Access Compliance Report

Public Rights-of-Way

(Curb Ramps)

Intersection ID: 14939	Main Street: HOLLYFIELD_DR	Cross Street: JENKINS_DR	Location: NW
ADA ID: 4D3E6AE86249	Ramp Type: Perp	Initial Pass/Fail: Fail	Overall Compliance: No
		Severity Score: 1.25

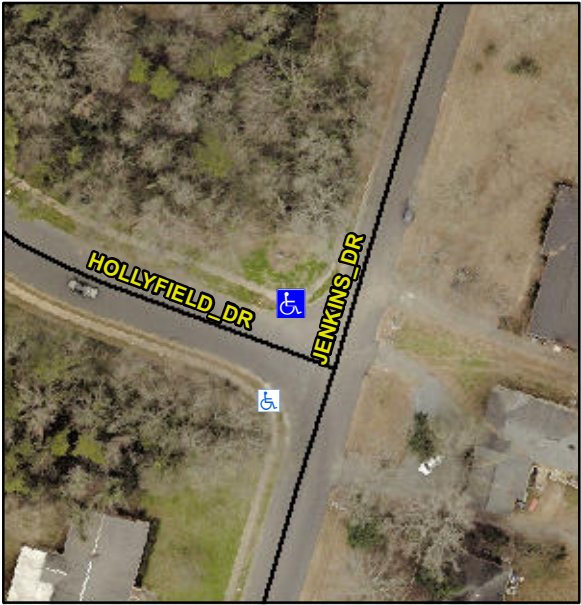
Codes/Mitigation Info/Possible Solution			Field Measurements/Component Compliance		
	Possible Solutions:		Compliance	Description	Data
	Remove & Replace Entire Ramp.		Yes	Ramp Length (in)	102.0
			N/A	Ramp Width (in)	48.0
			N/A	Flare Type LT	N/A
			N/A	Flare Slope LT (%)	N/A
			N/A	Flare Traversable LT?	N/A
			N/A	Flare Traversable RT?	N/A
			N/A	Landing Length (in)	N/A
			N/A	Landing Width (in)	N/A
			N/A	Landing Slope (%)	N/A
<p>Surveyor Notes:</p> <p>N/A</p>			N/A	Landing X Slope (%)	N/A
			N/A	Landing Curb? (Y/N)	N/A
			N/A	Shared Landing?	N/A
			N/A	Gutter Ponding?	N/A
			N/A	Gutter Lip Ht (in)	1.0
			N/A	Painted X Walk1?	No
			N/A	X Walk 1 Direction	To SW
			N/A	X Walk 1 Width (in)	N/A
			N/A	X Walk 1 Slope (%)	3.9
			N/A	X Walk 1 X Slope (%)	1.7
<p>PROW/ADA:</p> <p>Not Found, R304.5.3</p>			N/A	X Walk 2 Direction	N/A
			N/A	X Walk 2 Width (in)	N/A
			N/A	X Walk 2 Slope (%)	N/A
			N/A	X Walk 2 X Slope (%)	N/A

N/A	Ramp inside XWalk1?	N/A
			N/A	Ramp inside XWalk2?	N/A
			N/A	Road Slope (%)	N/A
			N/A	Road X Slope (%)	N/A
			N/A	Any Obstructions?	N/A
			N/A	Obstruction Type	N/A
Total Cost:		\$ 1850.00	N/A	Clear Space?	N/A
			N/A	Clear Space to XWalk (in)	N/A
			N/A	Storm Grate/Utility Hazard?	N/A
			N/A	Storm Grate/Utility Type	N/A
			Yes	Surface Condition? (G/P)	Good
